CERTIFICATE OF APPROPRIATENESS

Property: 8234 Glen Valley Drive, Lot 9, Block 8, Glenbrook Valley Section 3 Subdivision. The property includes a historic 2,931 square foot, one-story brick veneer single family residence and detached garage situated on an 11,400 square foot (95' x 120') corner lot.

Proposal: Alteration – The applicant was issued a stop work order for replacing windows and the roof without proper permits. The applicant replaced the original fixed decorative windows, aluminum 4-lite sash windows, and single lite slider windows with aluminum divided lite sash and fixed windows. An original rear hip roof was replaced with a stacked gable roof- the roof ridge increased from 14' to 18'.

EAST ELEVATION – FRONT FACING GLEN VALLEY DRIVE

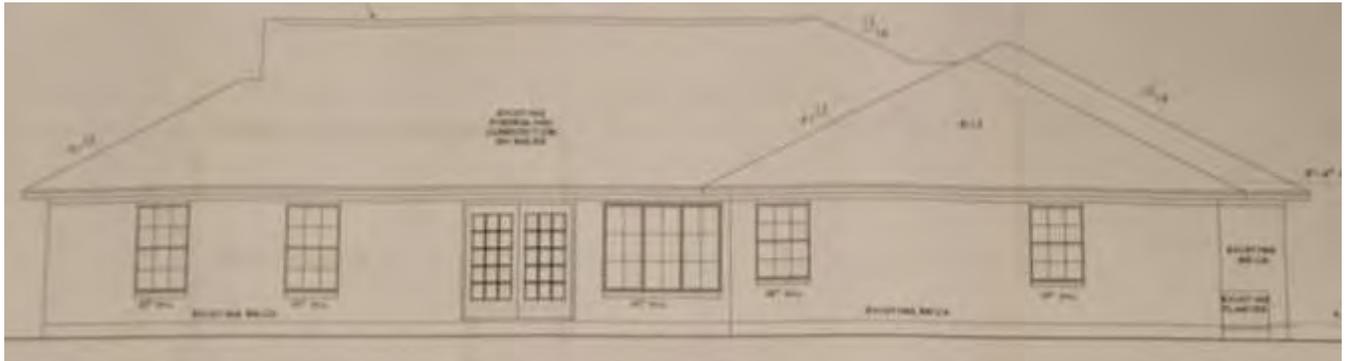
Front Elevation: Replace ten fixed decorative fixed windows with ten single lite casement windows (previously proposed 6-over-6 sash windows). Replace two 4-lite sash windows with two 1-over-1 sash windows (previously proposed 6-over-6 sash windows) and replace two 2-lite slider windows with three single fixed windows (previously proposed 6- lite fixed windows). The window openings will not be modified.

SOUTH SIDE ELEVATION FACING BELLFORT
ORIGINAL /PROPOSED

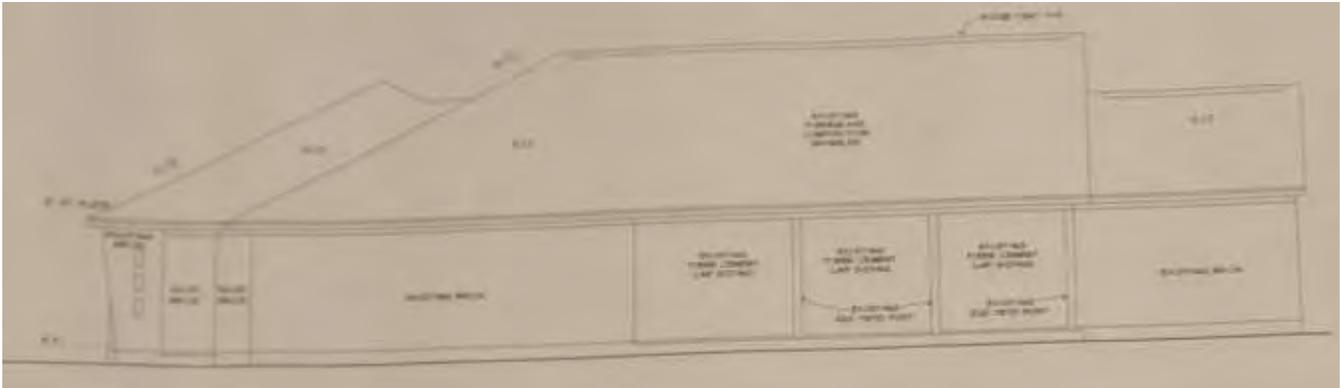
Side Elevation: Replace four 4-lite sash windows with four 1-over-1 sash windows (previously proposed 6-over-6 sash windows) and replace three decorative fixed windows with three single lite casement windows (previously proposed 6-over-6 sash windows). The window openings will not be modified.

Remove a 6-lite non-original wall enclosure and construct a new wall clad with brick. The wall will feature two 1-over-1 sash windows (previously proposed 6-over-6 sash windows).

WEST (REAR) ELEVATION

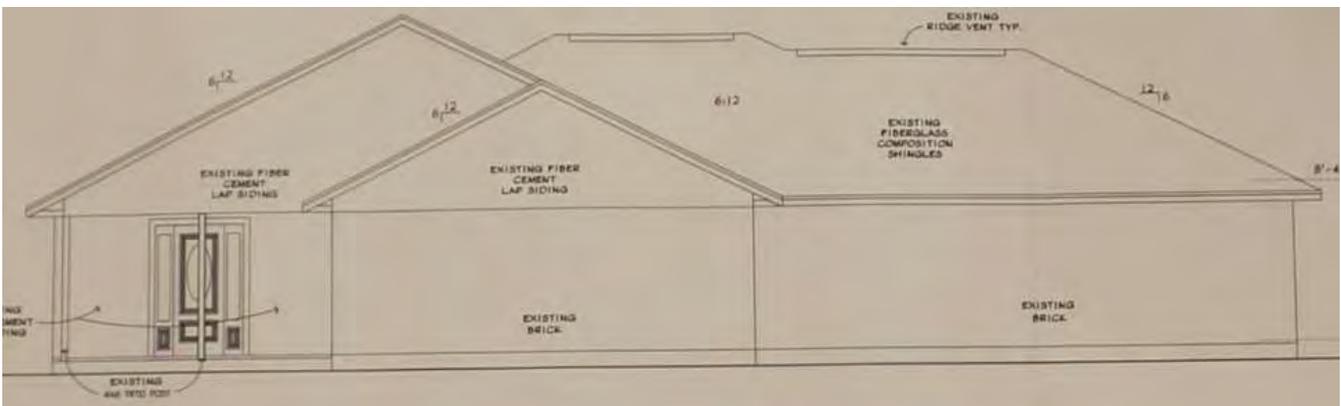
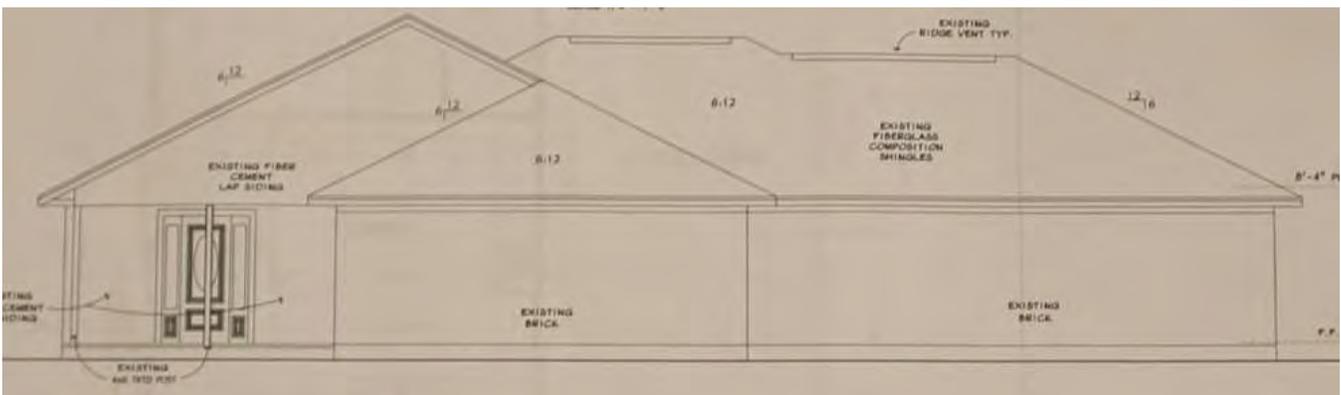
Rear Elevation: Replace two 2-lite slider windows with three single lite fixed windows (previously proposed 6-lite (West) fixed windows). The window opening will not be modified.

ROOF PLAN

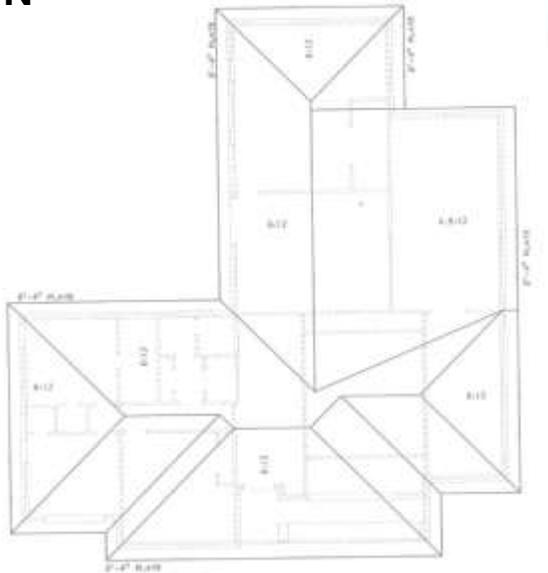
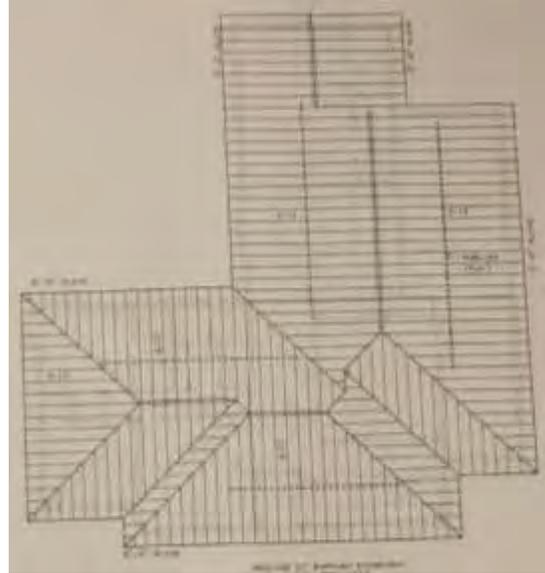
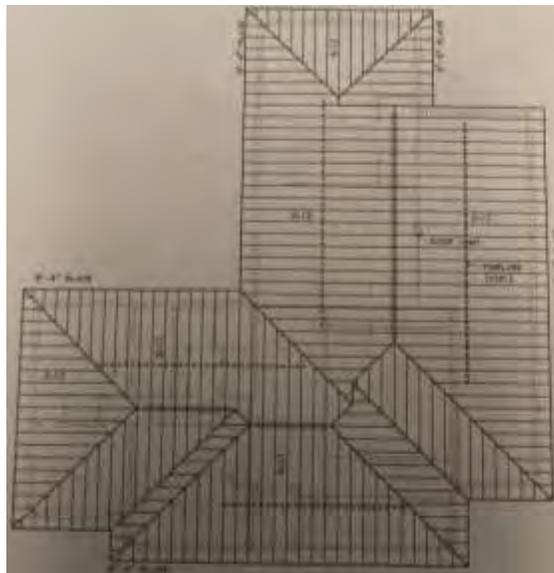
Roof: The residence featured a hipped roof with closed eaves and a 6/12 roof pitch. The roof was damaged by a fire and caved in. The roof was rebuilt back to match the original roof structure, the pitch and height did not change. An original rear hip with a 6/12 pitch and a non-original shed roof with a 4/12 pitch were removed and replaced with a stacked gable roof with closed eaves and a 6/12 pitch. The stacked gable roof will be removed and the hip and shed roof will be reinstalled (previously proposed gable on hip roof). The hip roof will feature closed eaves and a 6/12 pitch and the shed roof will feature a 4/12 pitch (previously proposed gable on hip roof with closed eaves and a 6/12 roof pitch).

PROPOSED WINDOW SPECS

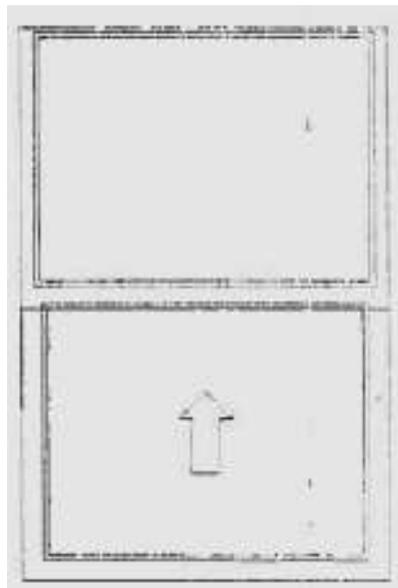
8234 Glen Valley: The use of vinyl clad windows with wide frames and sashes is not an acceptable replacement of the original thin framed aluminum windows.
